10/532,552

Office Action Summary

DETAILED ACTION

Drawing Attachment 1

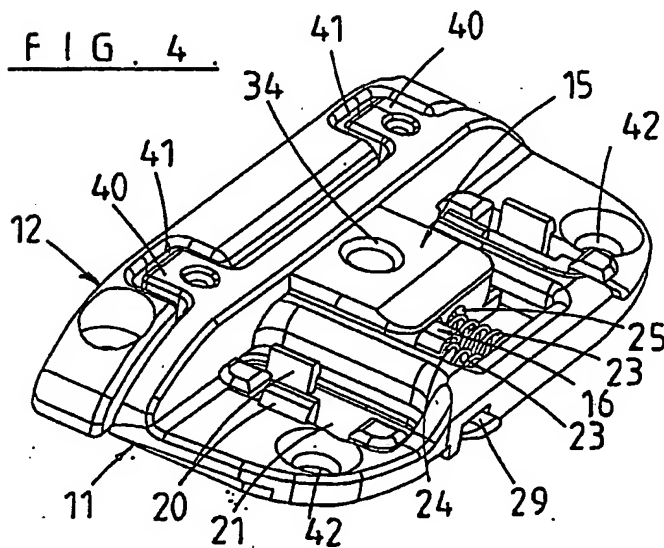
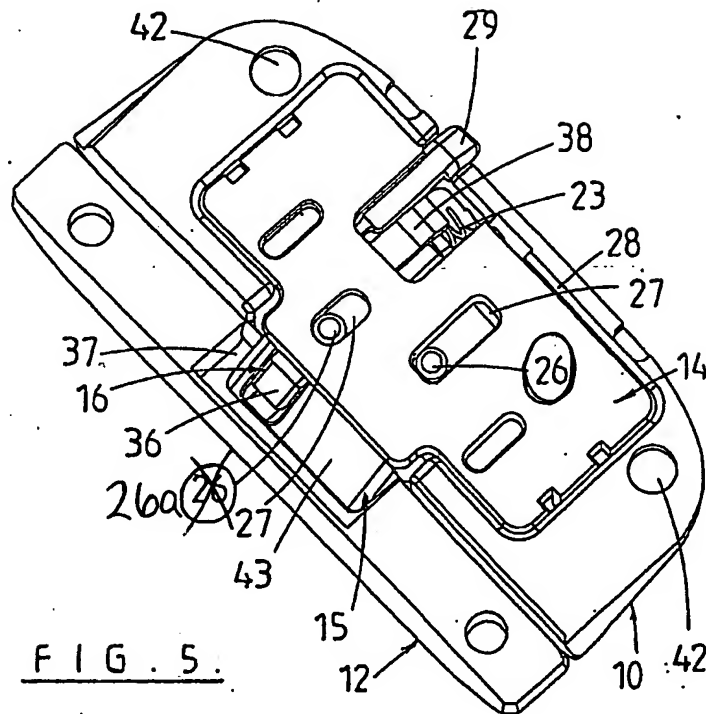
10. After further review of the application, the drawings are objected to because the interaction between the primary bolt and the secondary bolt when incorporating the trigger clip for retaining the primary bolt is not clear from the drawings. Specifically, it is unclear from the drawings how the primary bolt is retained by the trigger clip, since it seems from the drawings that the secondary clip is in line with the trigger clip not an engaging portion of the primary bolt. Corrected drawing sheets in compliance with 37 CFR 1.121(d) are required in reply to the Office action to avoid abandonment of the application. Any amended replacement drawing sheet should include all of the figures appearing on the immediate prior version of the sheet, even if only one figure is being amended. The figure or figure number of an amended drawing should not be labeled as "amended." If a drawing figure is to be canceled, the appropriate figure must be removed from the replacement sheet, and where necessary, the remaining figures must
